On Wednesday, September 25, I attended a meeting of the Redlands Airport Association at the Redlands Airport. Captain David Zamiska of the UPS (United Parcel Service) Flight Operations Technical and Safety team gave a 30-plus minute discussion pertaining to the UPS Airlines effort to establish at San Bernardino International Airport, (a) a "visual approach" for Runway 24, (b) an RNAV (RNP) instrument approach to Runway 24, and (c) an RNAV (RPN) approach to Runway 6 – suitable for their larger 767 cargo jets; and in a few years, suitable for 747 and 777 cargo jets.

UPS is developing 3 instrument approaches, 1 visual approach, and 2 departure procedures for SBD. The handouts (attached) they shared included a plotting of the draft visual approach and the two draft instrument approaches (RNAV Z Rwy 24 & RNAV X Rwy 6). I have asked them for the third instrument approach and 2 departure procedures. The visual approach is a company procedure. The instrument approaches will be public. Their use will require authorization because it requires certain GPS equipment and training to use the approach. It is realistic to see other operators use the instrument approaches if they are authorized.

Visual Approach KSBD Runway 24

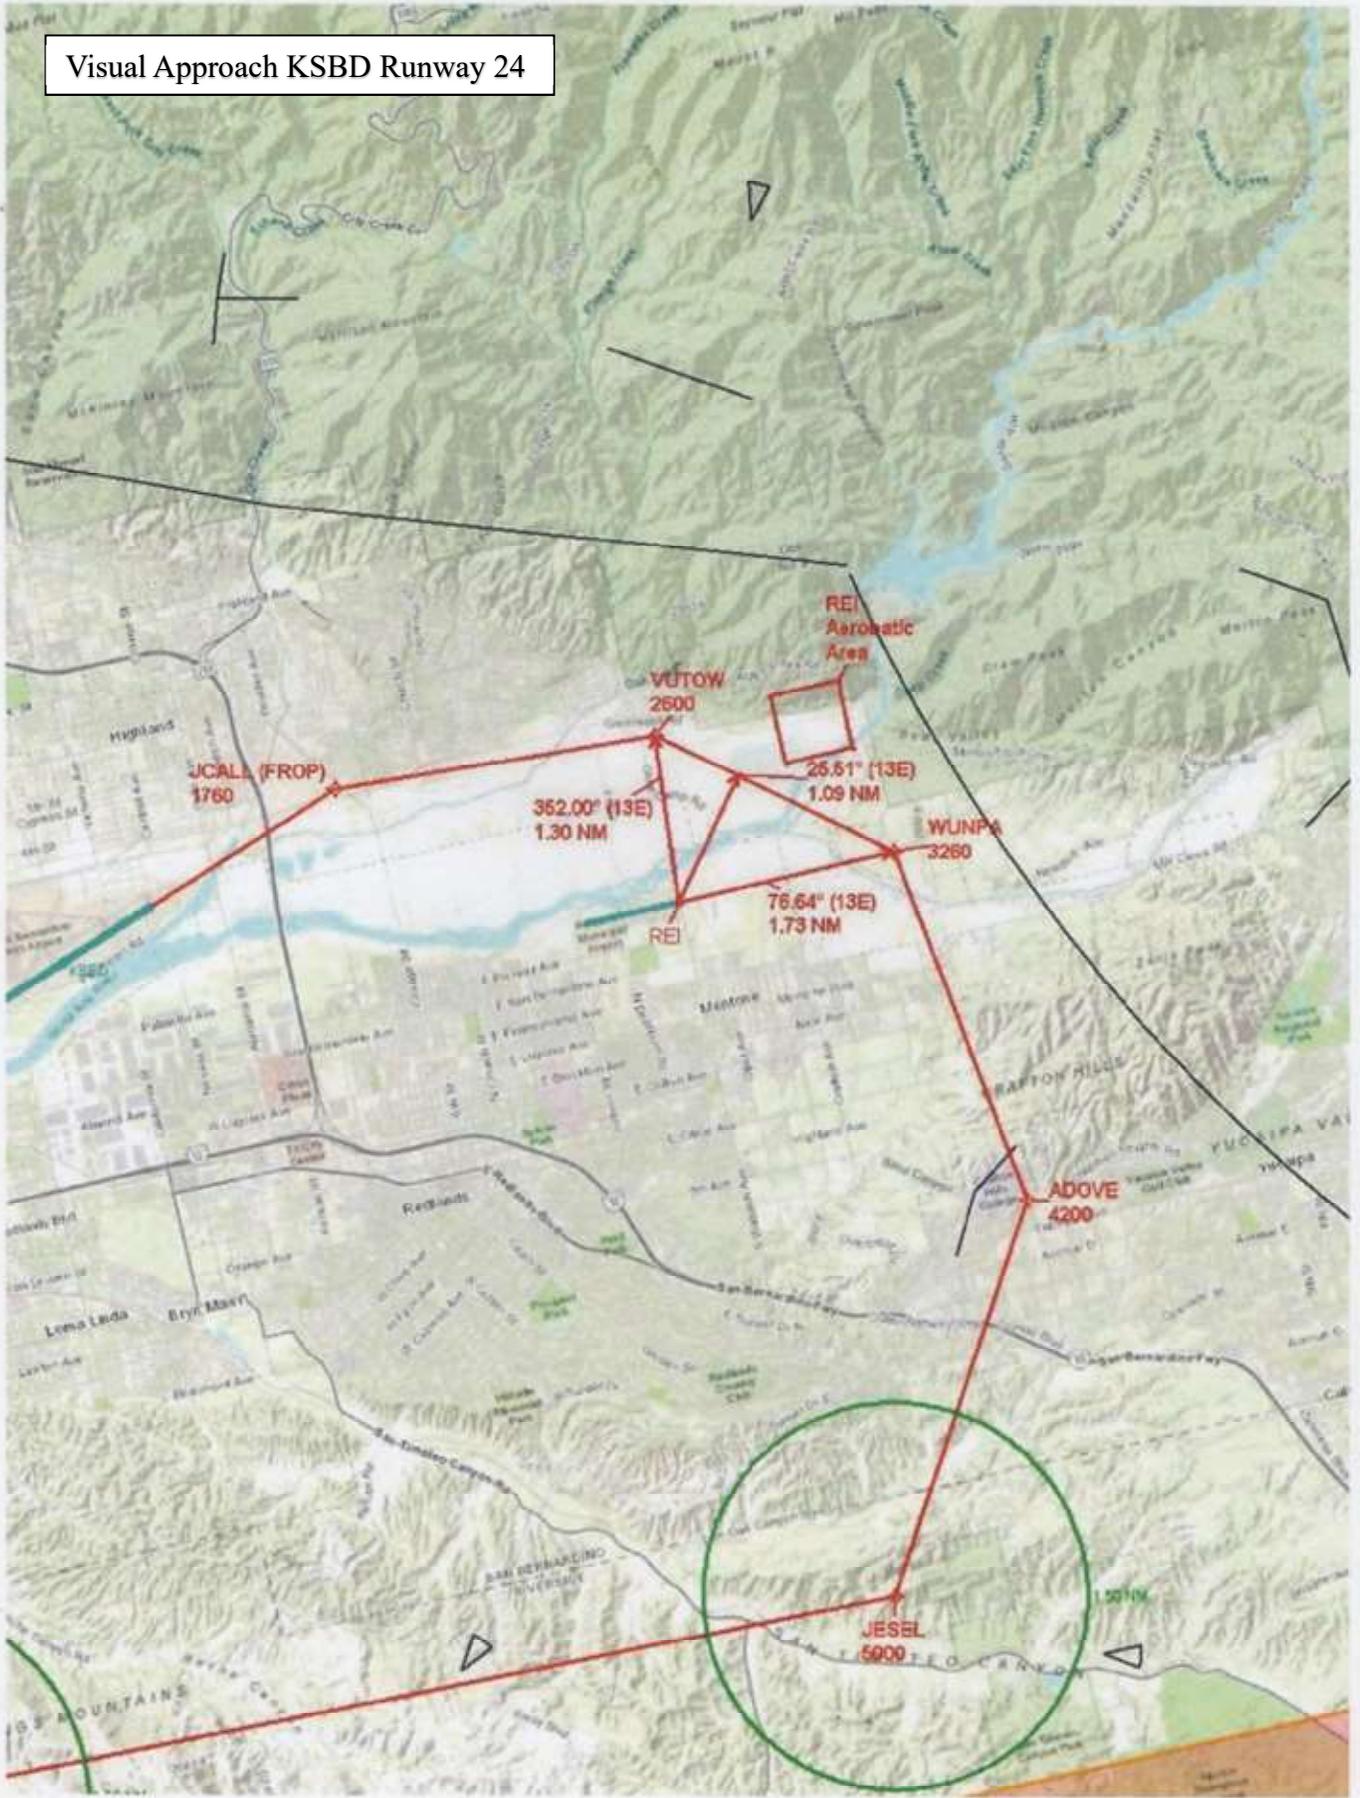
1. The UPS internal visual approach is almost identical to the proposed RNAV (RNP) Z Rwy 24 approach -- although the "waypoint" names are not quite the same. JESEL on the visual approach appears to be CASSE on the RNP plate; and the other visual waypoints are not identified on the RNP plate until reaching JACAL. Captain Zamiska did mention that both all of the charts are still under development and that some of the waypoint names have already changed; or will be changed.

As you review the appended "visual approach", keep in mind that it is for internal UPS use only. It is a draft only. It will eventually take a form similar to the Jeppesen chart formats, but not until the waypoints have been unified and confirmed.

One "casual" note -- one of the folks at the Redlands Airport meeting was flying in the pattern at Redlands (including at least downwind segment) as a UPS 767 was flight testing the visual approach to San Bernardino. That pilot noted that he was above the 767 on visual approach to San Bernardino while downwind at Redlands. He stated that he was well inside of the 767 and could easily see the 767 as well.

Zamiska made the point that the intent of the visual approach (and RNAV (RNP) Z 24 approach) is to be well outside the Redlands pattern area and below the Redlands downwind altitudes to ensure against wake turbulence.

Still, as a pilot, I would have some concern if I were in a high pattern at Redlands, particularly as I turned base -- since the jets could be flying counter-direction and descending through my altitude as I turned that base leg. However, assuming Runway 26 at Redlands was in use, the winds would be blowing any wake turbulence from a 767s up the canyon and away from the base leg ... great in theory, but reality is another exercise.

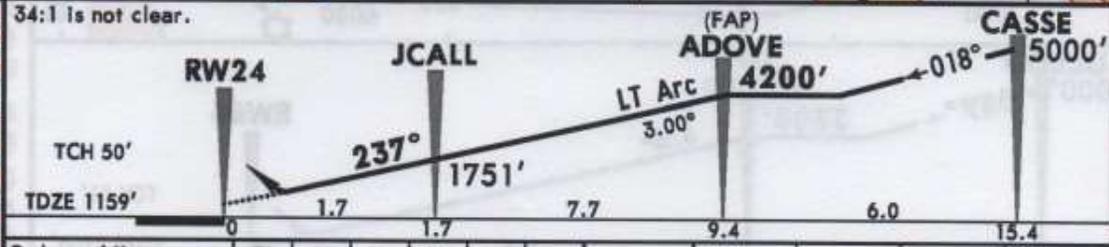
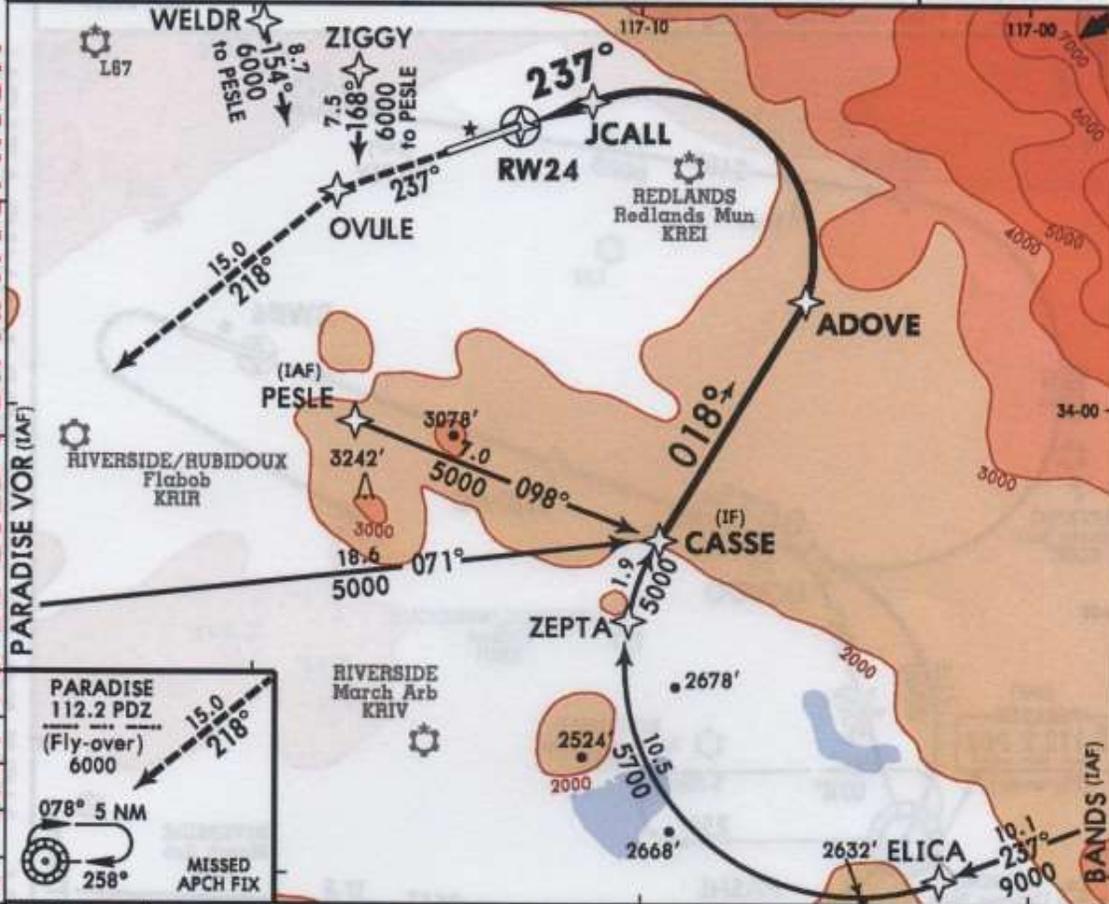
6. However, the RNAV (RNP) Z to Runway 24 DOES originate via ZIGGY waypoint (which is part of the EAGLZ approach), descending to 6000' over Lake Arrowhead enroute to PESLE waypoint. The WELDR intersection initial approach waypoint that also leads to the PESLE waypoint appears to be west of the Lake Arrowhead area -- but I would need to fly that to be sure.

RNAV (RNP) X Rwy 6

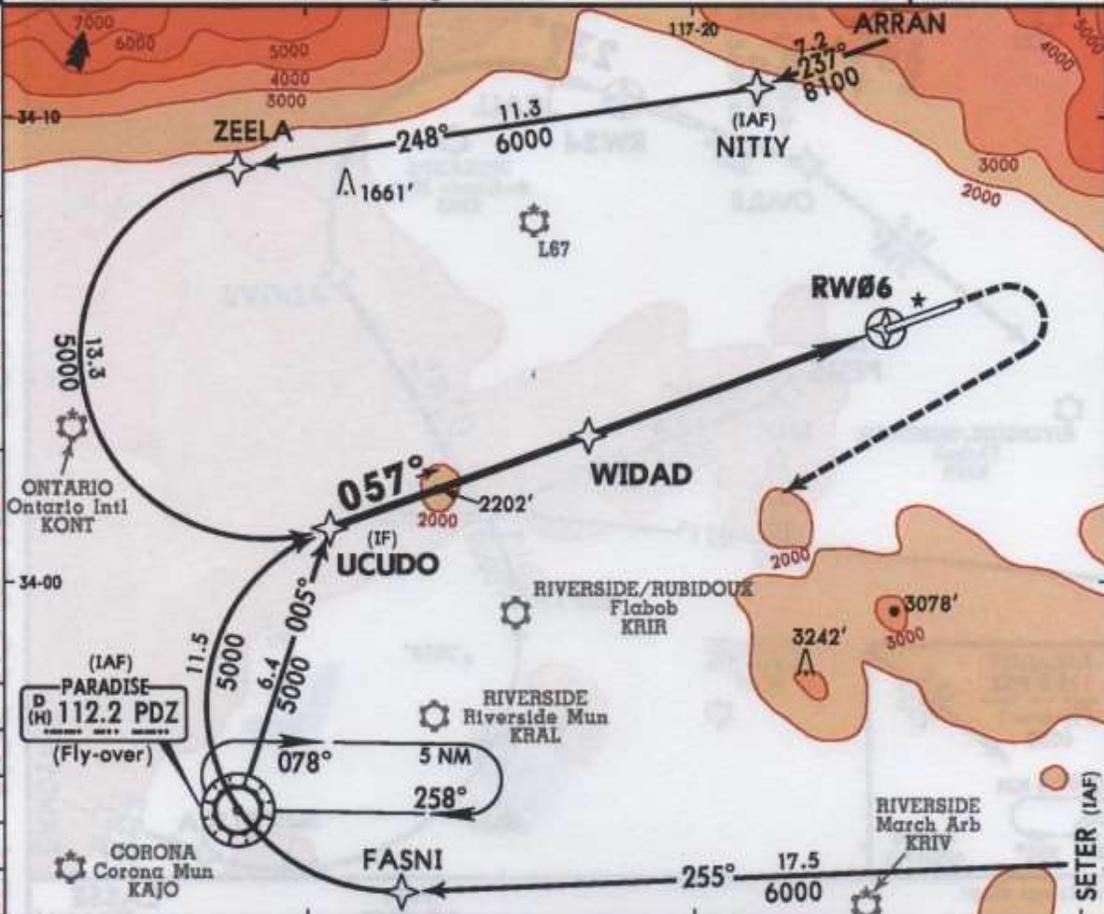
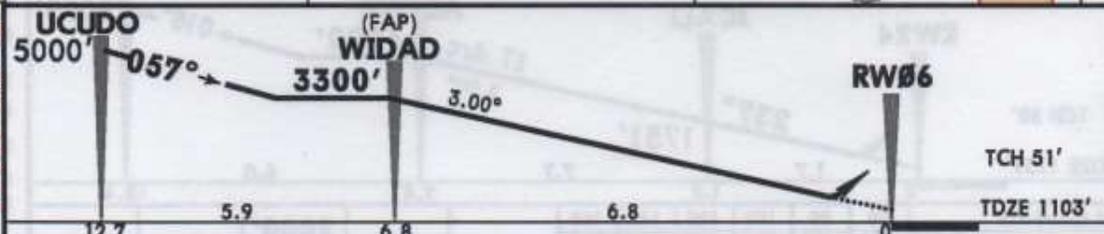
2. The RNAV (RNP) X Rwy 6 is almost the same as the RNAV (GPS) Rwy 6 approach ... but it added the NITTY waypoint approach for airplanes approaching from the north or east ... and the published altitudes are 1000 feet higher at the Initial Fix (IF), UCUDO, and a slightly higher DA (Decision Altitude) at 1409 feet (306 feet above ground) versus 1353 feet (250 feet above ground) for the GPS approach. There are slightly higher visibility requirements as well (1 mile vs. 3/4).

It is worth noting that the Los Angeles FLY chart depicts a VFR traffic corridor through this area below 9500' ... and the UPS chart has their jets descending from 8100 feet down to 6000 feet in this same airspace. But the jets are big ... so most VFR pilots should see them (although wake turbulence could still be an issue).

5. While not particularly relevant to the Redlands group but certainly relevant to the Lake Arrowhead folks, the proposed UPS RNAV (RNP) X approach to Runway 6 does suggest that the UPS flights will be flying into KSBD over the ARRAN waypoint (which is a waypoint on Victor 8 just past over Heap's Peak) ... east of the currently impacted Lake Arrowhead area . Whether the FAA would opt to "join" UPS flights via the current EAGLZ approach is something that only the FAA would know.
